Technical Service Bulletin

34 - 6th gear jumps out - 0B1/0B2 gearbox

34 13 15 2026719/4 February 14, 2013. Supersedes Technical Service Bulletin Group 34 number 13-14 dated January 30, 2013 for reasons listed below.

Model(s)	Year	VIN Range	Vehicle-Specific Equipment
A4	2010-11	All	2.0L with manual transmission
A5	2010-11	All	2.0L with manual transmission

Figure 1. Shift fork and gear shift unit

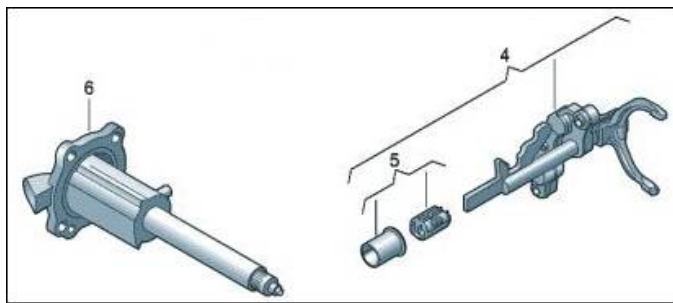
The transmission jumps out of 6th gear.

Improved 5th and 6th shift fork and gearshift unit.

4. Replace the 5th - 6th gear shift fork and ball sleeve (*Item 4 and 5, Figure 1*) and the gear shift unit (*Item 6 Figure 1*) per instructions in *ELSA: Transmission*>> *Manual Transmission Internal Components*>> *34 Controls, Housing*>> *Disassembly and Assembly*>> *Transmission, Assembly Sequence* **AND** *35 Gears, Shafts*>> *Disassembly and Assembly*>> *Shift Fork Group, input shaft*.

Tip: When replacing the shift fork and ball sleeve, no further disassembly of input shaft is required.
